100/300 AREA UNIT MANAGER MEETING ATTENDANCE AND DISTRIBUTION

100 & 300 AREA UNIT MANAGER MEETING MINUTES

Groundwater and Source Operable Units; Facility Deactivation, Decontamination, Decommission, and Demolition (D4); Interim Safe Storage (ISS); Field Remediation (FR); Mission Completion; and 100-K Sludge Treatment Project and 100-K Facility Demolition and Soil Remediation projects

January 10, 2013

Figure 1. UPR-100-N-4, UPR-100-N-8, and UPR-100-N-31 Grouping of Waste Sites Shallow Zone Additional Remediation Sketch.

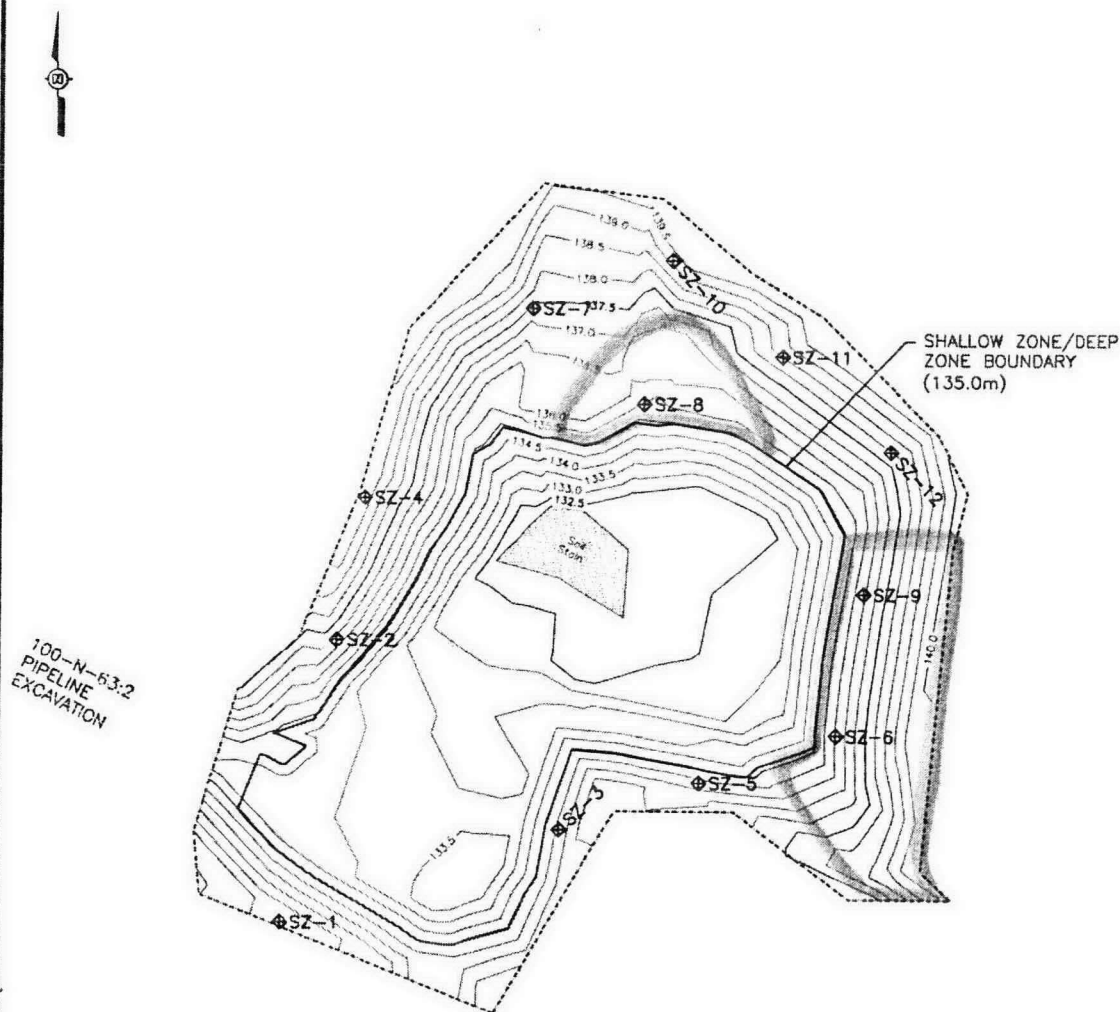
Washington Closure Hanford proposes additional soil to be removed from the UPR-100-N-4, UPR-100-N-8, and UPR-100-N-31 grouping of waste sites at the SZ-6, SZ-8, and SZ-9 locations for disposal at the Environmental Restoration Disposal Facility. To be conservative, generally, half the distance between the failed verification sample location and the nearest passing verification sample location is used as the boundary for additional soil removal (Figure 1). The depth of additional soil removal will be between 1 to 2 meters depending on observations in the field (e.g., discolored or stained soil, debris, etc.). Additional soil removal is limited to the shallow zone only.

Figure 1. UPR-100-N-17 Bioventing Well Island Map

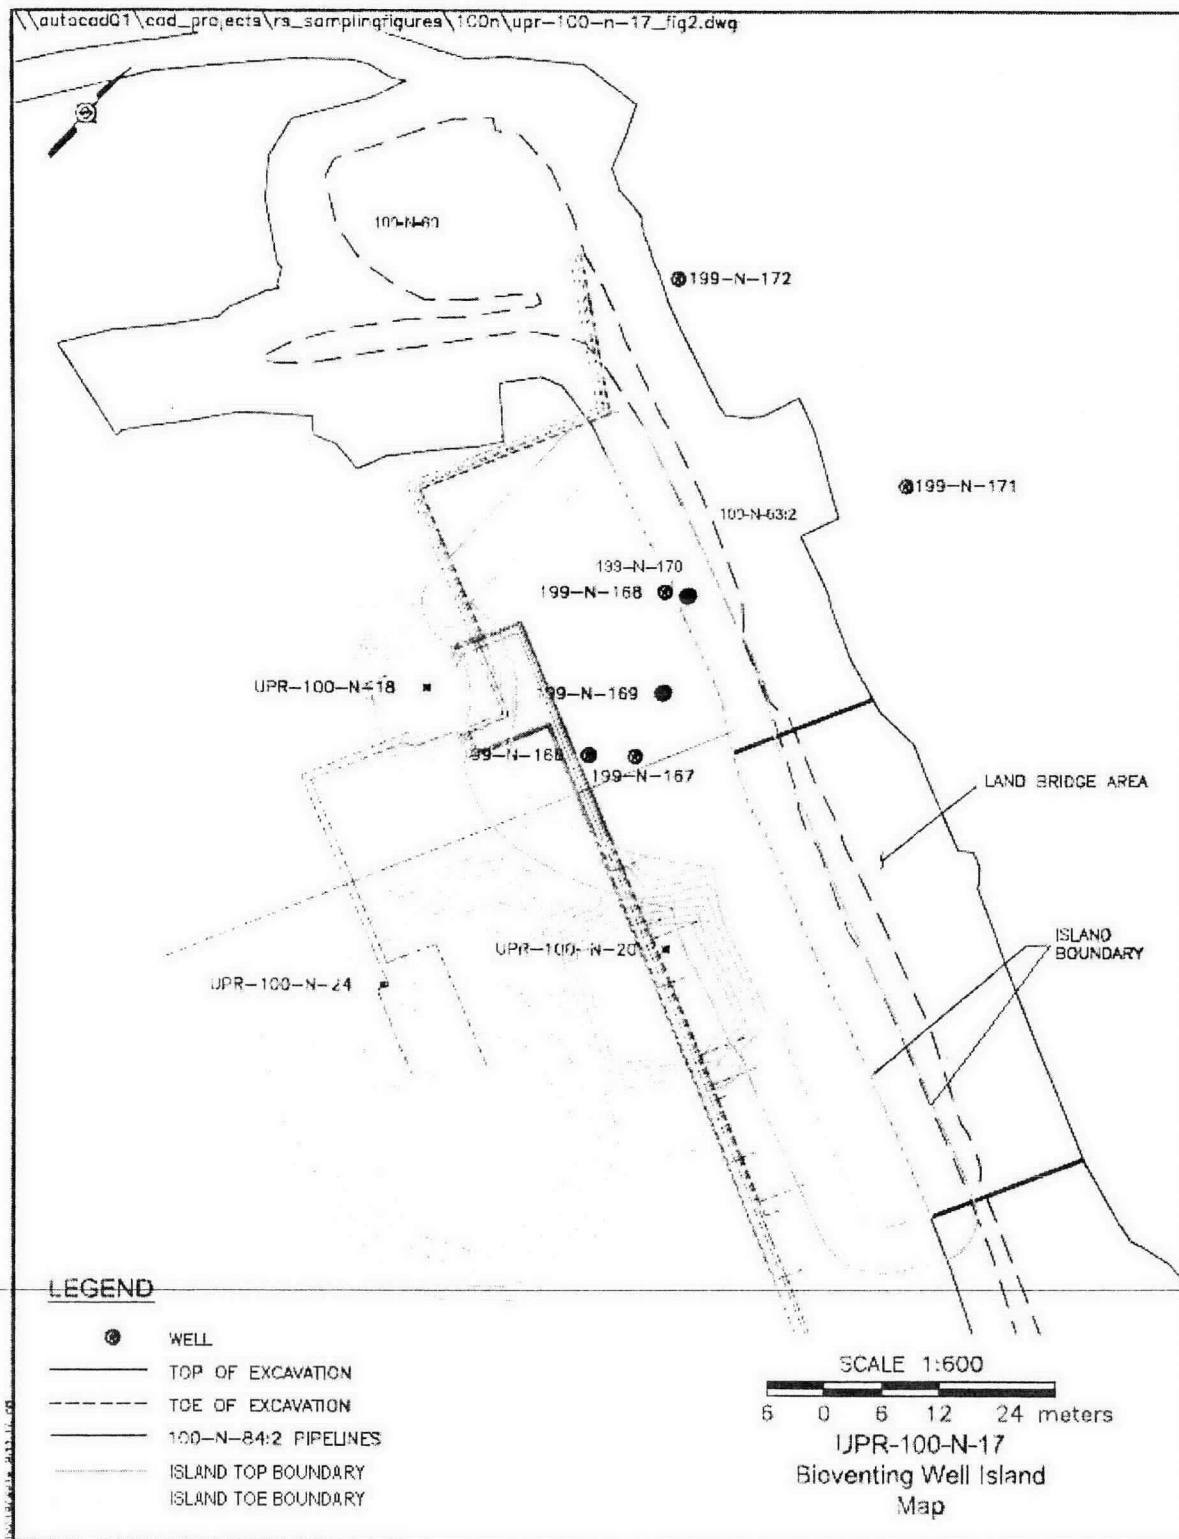
DOE and Ecology approve leaving in place an area of potentially contaminated soil (Bioventing Well Island) and sections of the 100-N-84:2, 100-N Area Fuel and Foam Pipelines waste site located around the 199-N-166, 199-N-167, 199-N-168 and 199-N-169 bioventing wells to maintain the integrity of these wells (Figure 1). The active 199-N-166, 199-N-167 and 199-N-169 wells have been identified for use in the in-situ bioventing treatment of UPR-100-N-17, 166-N Diesel Oil Supply Line Leak waste site. The Bioventing Well Island measures approximately 280 ft (64 m) long and 72 ft (22 m) wide at its widest point. The island shape allows staging and access for bioventing and groundwater sampling equipment and personnel and connects to the adjacent 100-N-63:2 land bridge.

Figure 1. Proposed Locations of Air Monitors.

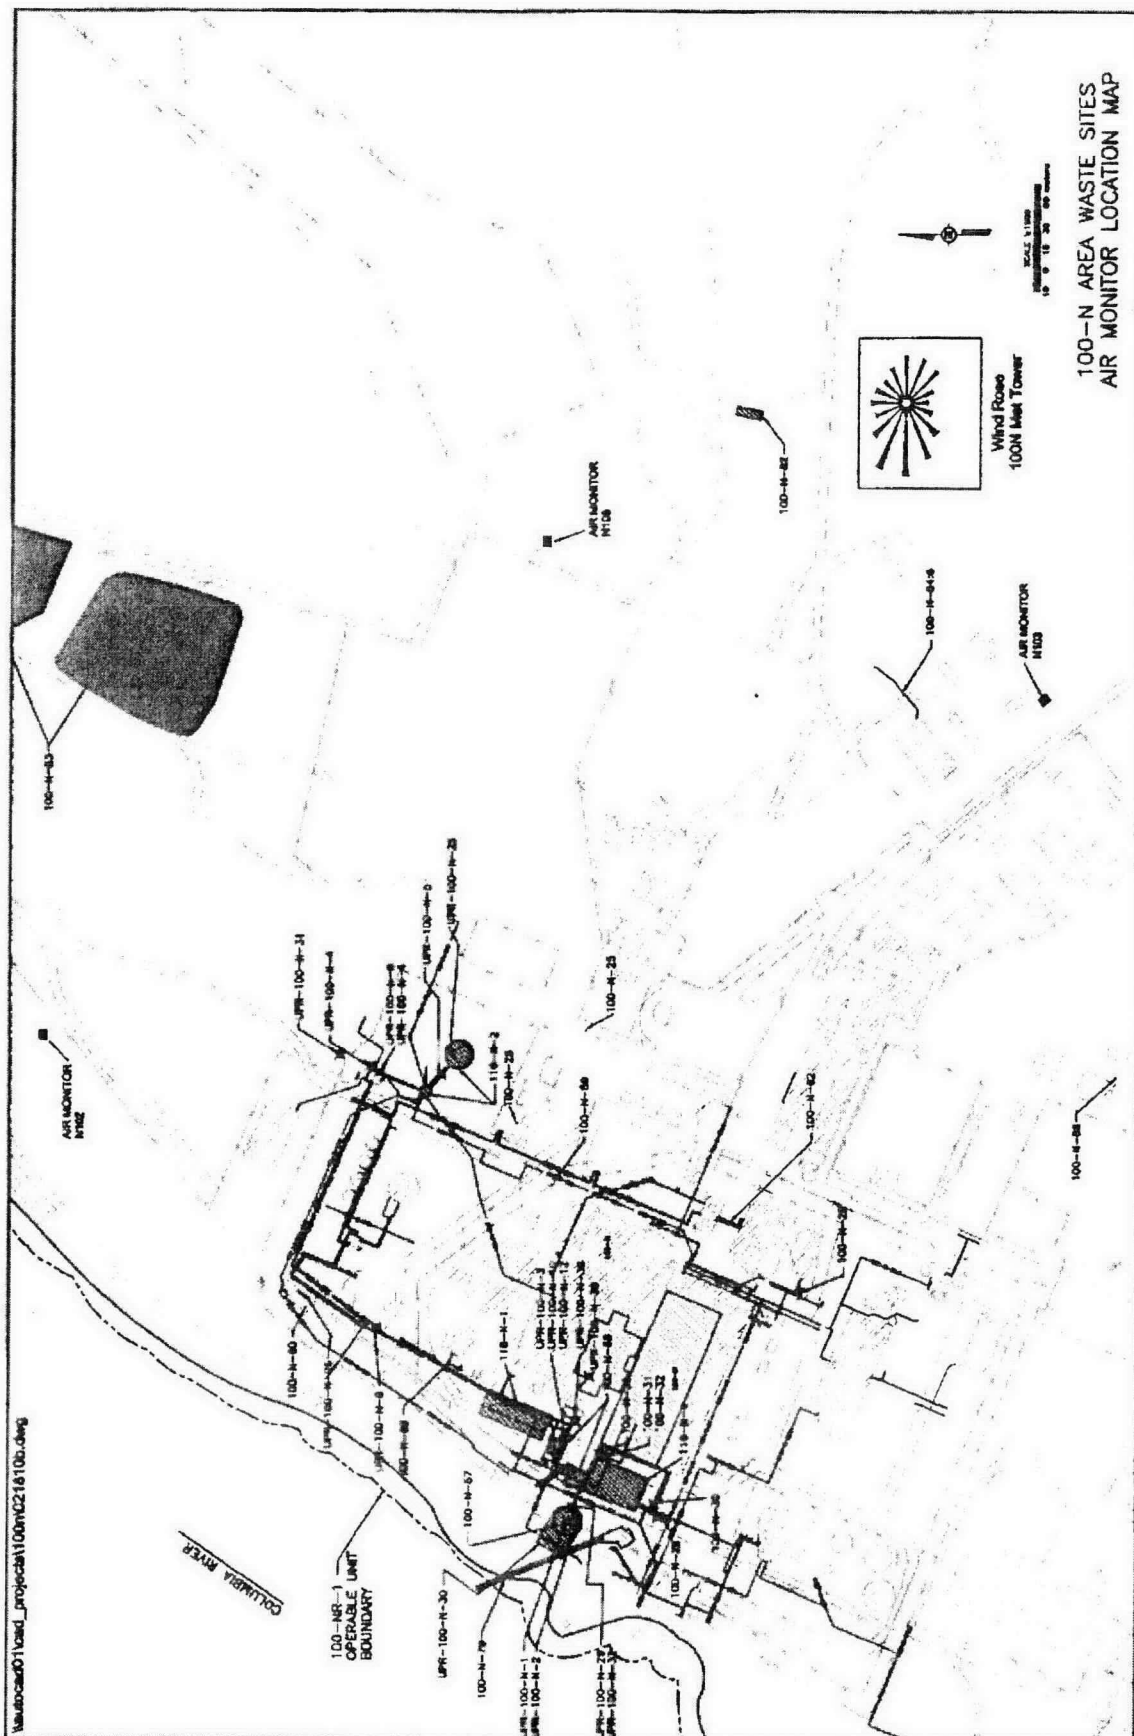
I looked at some CAP 88 runs for the for the revised 100-N AMP and it projects the highest dose East or East South East of 100-N. RAES concurs with moving to the proposed location, it is not likely affect monitoring capability for the area. Can you let us know when the move is complete and revise the draft November 2012 AMP to reflect the change?

This is an "updated" figure 1. For the 100-N air monitoring plan. They need to move an air monitor so that it has permanent electricity. Do you have any issue with its placement?

Here is a response approving air monitor move. Can you let me know when the move is complete and the draft November 2012 AMP is revised to reflect the change?

Figure 1. 100-N-61:1 Grouping of Waste Sites Additional Remediation at SZ4-10 Sketch.

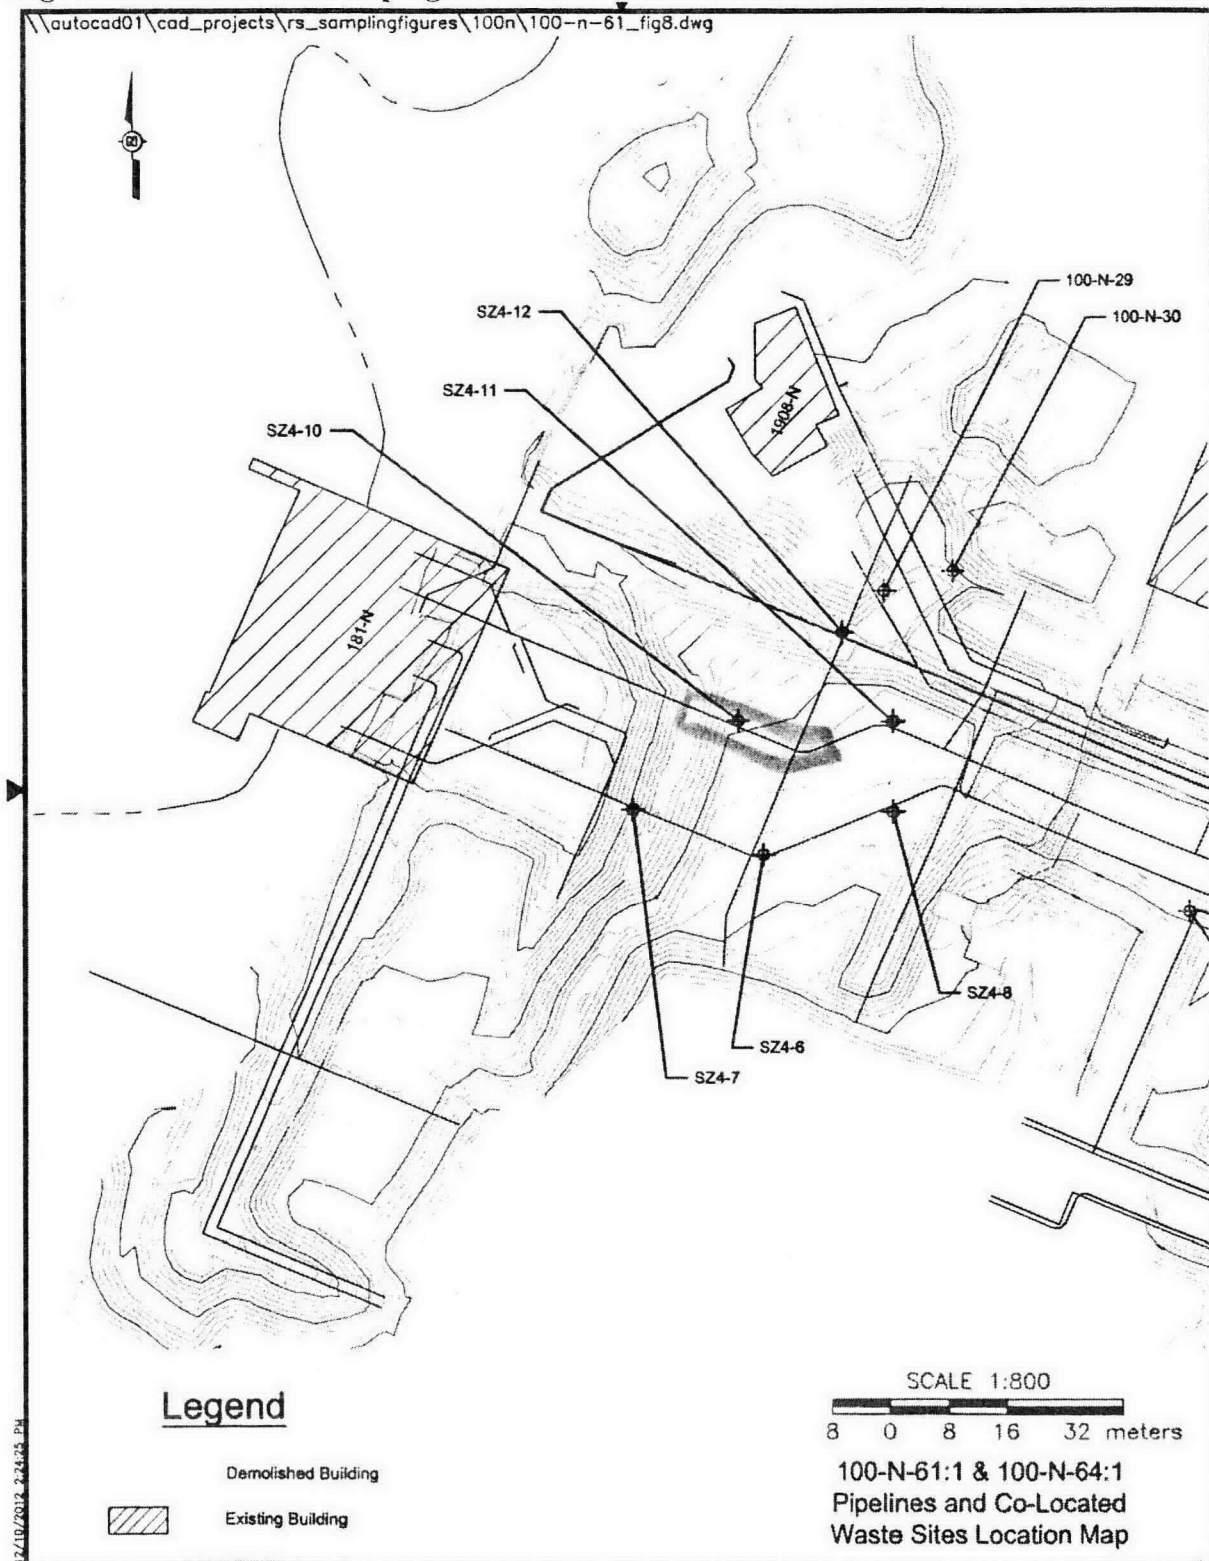
Washington Closure Hanford proposes additional soil to be removed from the 100-N-61:1 grouping of waste sites at the SZ4-10 and SZ3-7 locations for disposal at the Environmental Restoration Disposal Facility. Figure 1 and 2 shows the areas where additional soil will be removed. The width of additional remediation at SZ4-10 will be approximately 1 m (3 ft) on each side of where the pipeline was located and the length will be half the distance between the failed verification sample location and the nearest passing sample location (Figure 1). The additional remediation at SZ3-7 will be an approximate 20-ft diameter area to cover where the valve pit was located (Figure 2). The depth of additional soil removal will be between 1 to 2 meters depending on observations in the field (e.g., discolored or stained soil, debris, etc.).
